APPLICATION FOR VARIANCE

15-04-1

Name of project	State project number	County
Burnham Rentals		Monroe
Address of site (number and street, city, state, and ZIP code)		
330 S. Dunn St., Bloomington, IN 47401		
Type of project		
<input type="checkbox"/> New <input type="checkbox"/> Addition <input type="checkbox"/> Alteration <input type="checkbox"/> Change of occupancy <input checked="" type="checkbox"/> Existing

Name of code or standard and edition involved 1998 Indiana Building Code	Specific code section 310.4
--	---------------------------------------

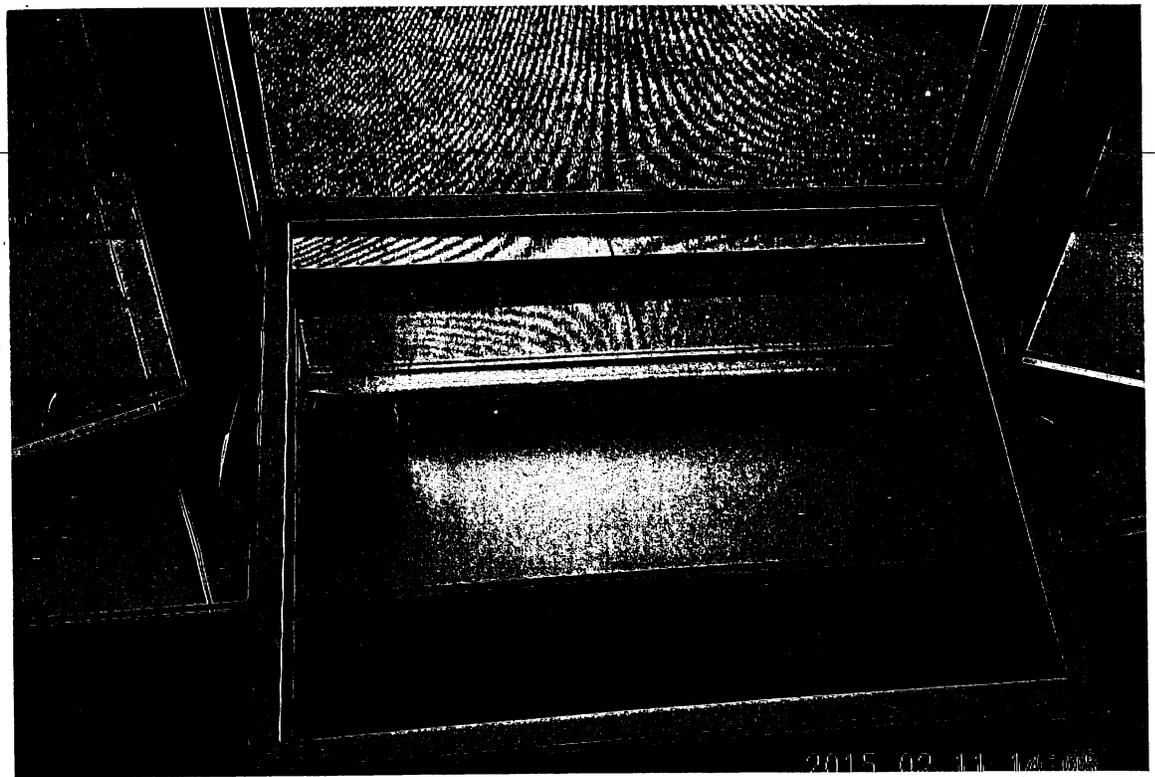
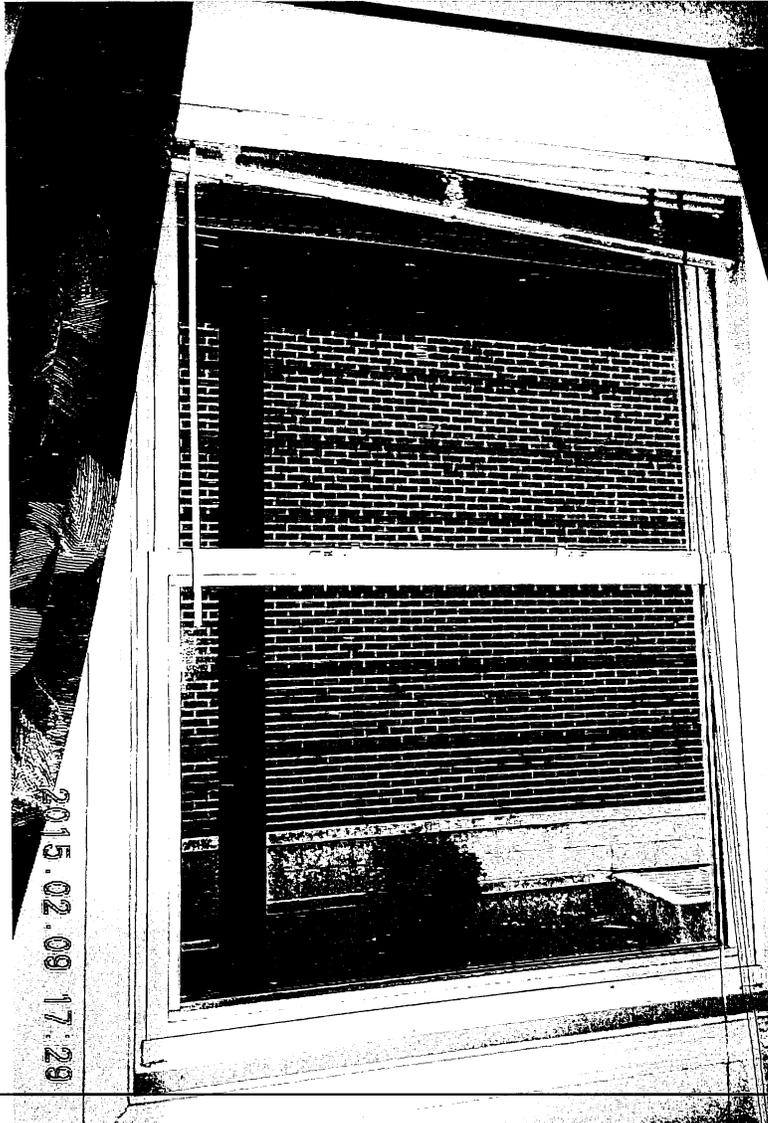
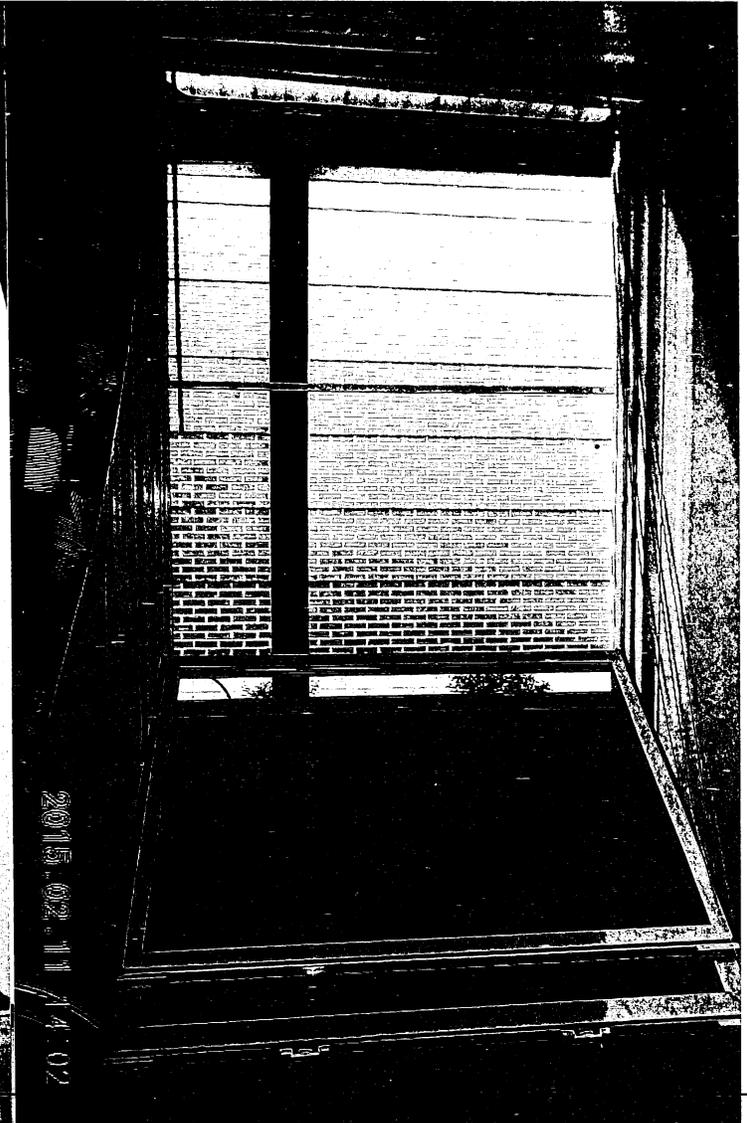
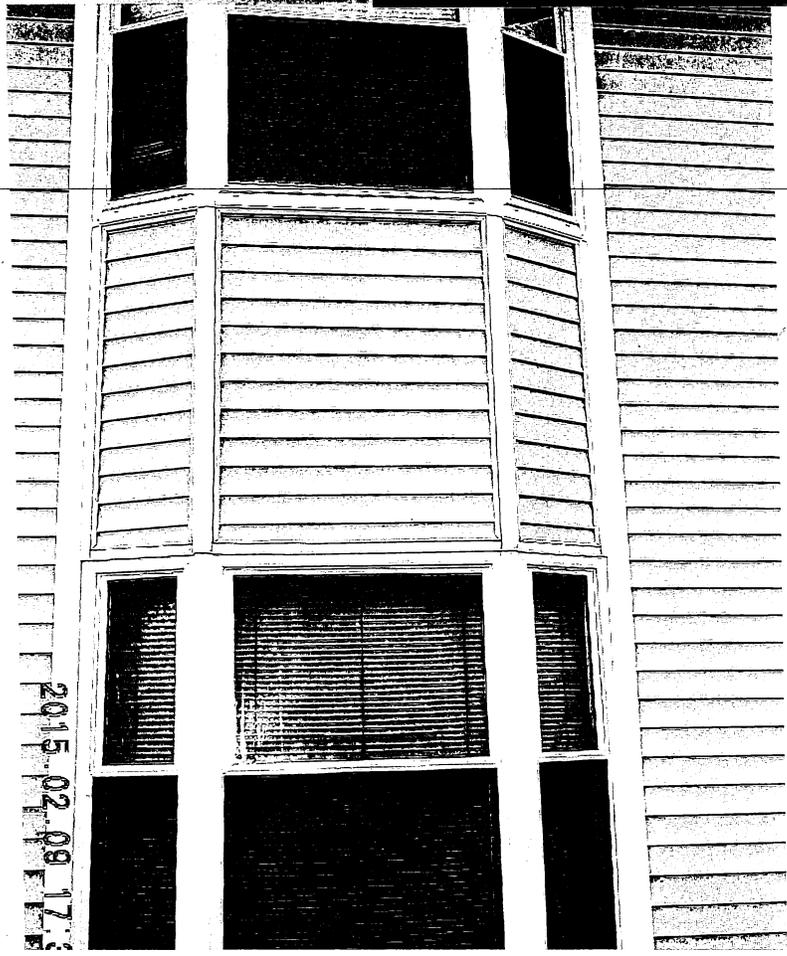
The actual window openings are very close to the required size by code. The HAND report states that the windows openable area measures 21 1/2 x 37 1/2" which measure out to 5.59 sq. ft. The required area is 5.7 sq. ft. All of these windows are double hung, tilt sash windows. The upper and lower sashes can be raised or lowered. Each sash can be tilted in and removed if needed for exit in seconds. 4 of the window openings with sashes removed are 51" h x 39" w. Each sash is 27 1/2" h x 39" w. 2 of the window openings with sashes removed are 53" h x 38" w. Each sash is 27 1/2" h x 38" w. I do not believe that the slightly reduced height opening is going to prevent anyone from exiting in case of an emergency. The additional 17" width beyond the minimum 20" inches required gives adequate room to escape if needed. Photos are included for IDHS.
